COUNCIL SUBMISSION – OBJECTION
9 Burroway Road, Wentworth Point - Mixed Use Development (SSD-72816207)
Response to Submissions

The below comments are provided following Council officer review of the *Response to Submissions* for the 9 Burroway Road, Wentworth Point Concept State Significant Development Application (SSDA).

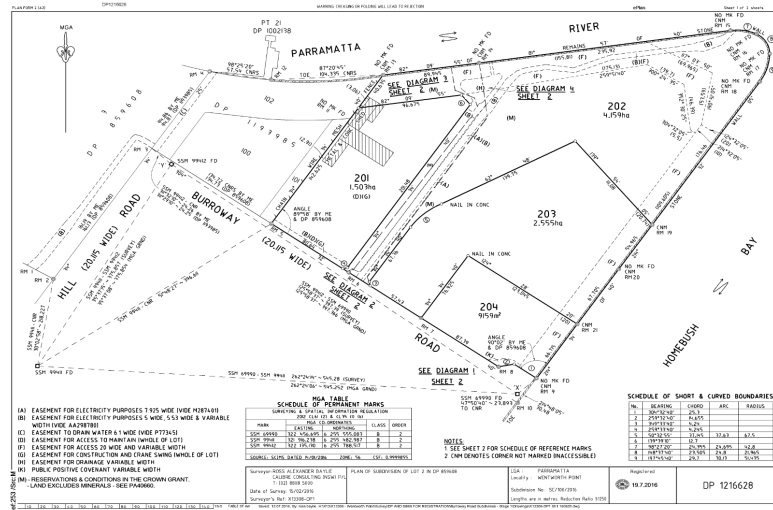
The application has not appropriately considered all of the land affectations of the subject site.

The subject site has a number of restrictions and covenants on the land which have been ignored in the EIS submitted.

Image 7b: Expected Wind Flow Patterns within the Proposed Development Site due to Southeast and East Sector Winds

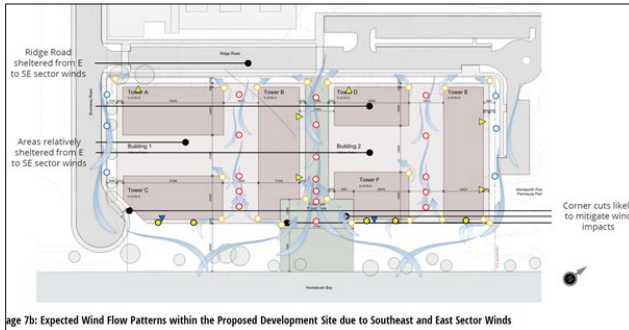
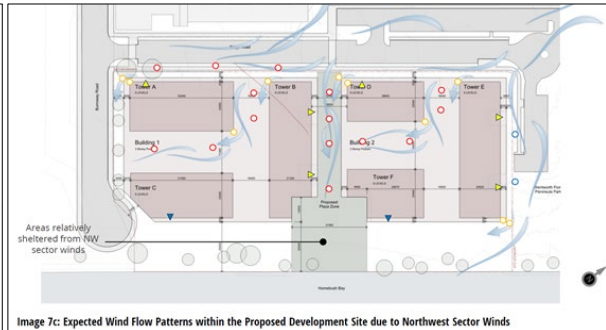
The SEARs suggest that wind tunnelling testing is required to inform optimum tower configuration to minimise wind impact at ground level. The applicant proposes this work as a detailed design activity following approval of the conceptual tower configurations. This potentially allows approval of tower configurations before optimal outcomes can be determined. The desk top wind study uncovers podium and public domain areas experiencing uncomfortable wind conditions suggesting the proposed tower configurations are not optimal. Council has suggested alternative tower configuration that the applicant declines to consider and that might deliver improved wind conditions. We suggest wind testing to inform optimal tower configuration prior to an approval is required.

We note also that wind mitigation recommendations in the desk top study are based on an understanding that there will be dense vegetation near the shoreline. This is not the case. There is little vegetation along the shoreline. Also, the ability of proposed tree species along the foreshore may have limited ability to mitigate wind impacts because:

- a. The density of proposed tree vegetation is sparse,
- b. The trees are relatively slow growing and have relatively open canopy habit, and
- c. The trees are also contending with contaminated soil conditions that may limit access to structural support/water at depth, and
- d. Limited soil volume is proposed for foreshore tree planting.

These conditions will constrain the vitality, health and long term viability of foreshore trees.

5. **Seawall**

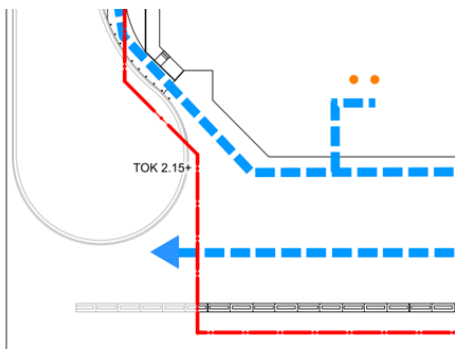
The proponent confirms that the seawall design will be confirmed and delivered as part of the development according to a design approved at S4.55 MOD 875/2017/B MOD (ref Seawall Arrangement 30105-0372-MA-DWG- 005 Rev. D – Advisian).

Council officers support the reconstruction of this seawall as it was meant to be carried out as part of the works for the peninsula park (which has since been deleted from construction). It is therefore imperative the works to the seawall are incorporated under this concept application. No documentation has been submitted to demonstrate seawall works. Details of the seawall (including a set of civil/structural seawall design drawings) should be included the SSD application document set.

Proposed TOK at Burroway Road RL2.15

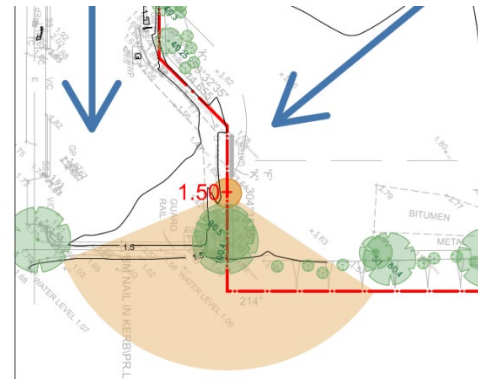
- a. **Levels** - proposed levels shown on design plans will be approved with any concept DA consent. The documentation submitted provides very few proposed RLs. Coordination of finished levels with the seawall or Burroway Road is not assured. The promenade is raised approximately 0.5m - presumably to meet the proposed top of seawall – this needs to be confirmed. How does the elevated foreshore promenade level interface with Burroway Road which is at least 0.5m below? See below drawing excerpts.

Existing level at Burroway Road RL1.5

Figure 2.2: Wicking Bed system (Source: Adapted from Citygreen standard details)

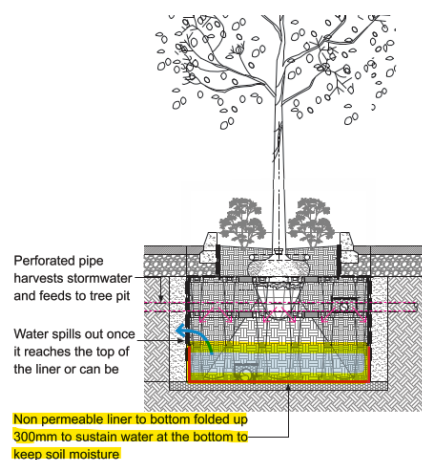
Council officers disagree with this response and note the treepit detail (Figure 2.2) states it has been adapted (altered) from the original 'City Green' detail.

The non permeable liner at the base (now showing a 150mm high fold-up as opposed to the previously detailed 300mm high fold) is not typical and is not supported by Council. This liner will act like a pond or OSD and will hold water in the base of the treepit creating anerobic conditions which is detrimental to a trees' root development.

In addition, the adapted City Green treepit detail has restricted the extent of the strata vault system to the narrow landscape bed which is futile and not supported by Council. The strata vault system should be shown to extend under the surrounding paving to increase the uncompacted soil zone as per City Greens' design ethos and to ensure the trees have access to sufficient soil volume to thrive into maturity.

It is imperative the design and extent of the treepit is amended at the concept stage including the above requirements to ensure the success of the trees within the proposal.
